UNITED STATES
DEPARTMENT OF THE INTERIOR
BUREAU OF LAND MANAGEMENTFORM APPROVED
OMB No. 1004-0137
Expires: January 31, 2018**SUNDRY NOTICES AND REPORTS ON WELLS**
**Do not use this form for proposals to drill or to re-enter an
abandoned well. Use Form 3160-3 (APD) for such proposals.**

8. Well Name and No. Toles Federal #3

Proposed P&A NOI
ConocoPhillips Company on behalf of M E W Enterprise
Orphan Well
Toles Federal #3
30-005-62479

**Toles Federal 3
30-005-62479
MEW Enterprise
July 15, 2025
Conditions of Approval**

PROPOSED Wellbore Diagram

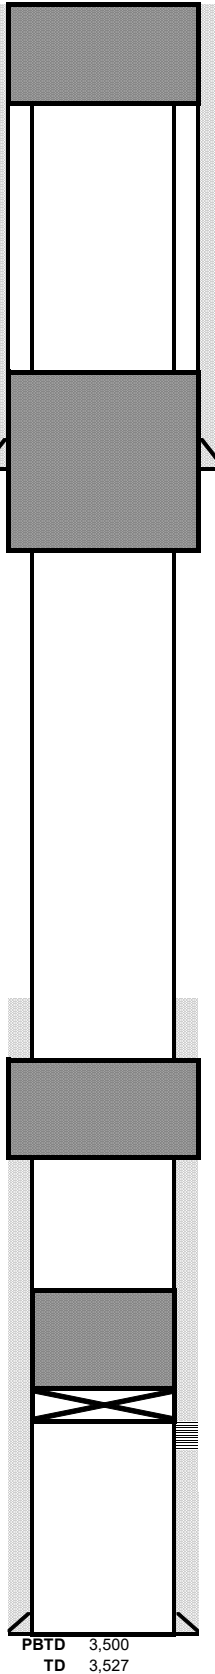
Plug #4: Perf & Squeeze 48 sxs cmt @ 100' to surface.
 (38 sxs outside, 10 sxs inside)

Perf & Squeeze 126 sxs class C cmt w/ 2% CaCl
Plug #3: @ 1,025-750'. WOC & Tag. (Yeso, Glorieta, 8 5/8" Shoe)
 (104 sxs outside, 22 sxs inside)

Plug #2: Perf & Squeeze 45 sxs class C cmt @
 2,380-2,280'. (Tubb)
 (35 sxs outside, 10 sxs inside)

Plug #1: Set 4 1/2" CIBP @ 3,015'. Spot 25 sxs class C
 cmt w/ 2% CaCl @ 3,015-2,687'. WOC & Tag.
 Abo perms 3,065-3,288'

- 1. Operator shall place a CIBP at 3,015' (50'-100' above top perf) and place 25sx of Class C cement on top. WOC and TAG.**
- 2. Operator shall perf at 2,380' and squeeze cement class C cement to 2,280' to seal the Tubb Formation as proposed. WOC and TAG.**
- 3. Operator shall perf at 1,025' and squeeze cement class C cement to 750' to seal the Yeso and Glorietta Formations along with the 8-5/8" shoe. WOC and TAG.**
- 4. Operator shall perf at 100' and squeeze cement class C cement to surface.**
- 5. Dry hole marker must be below ground.**
- 6. Surface reclamation will need to be completed once the well bore has been plugged. Please contact rflores@blm.gov for additional information.**
- 7. See attached for general plugging stipulations.**
- 8. See attached for New Mexico Oil Conservation Division's plugging guidelines.**
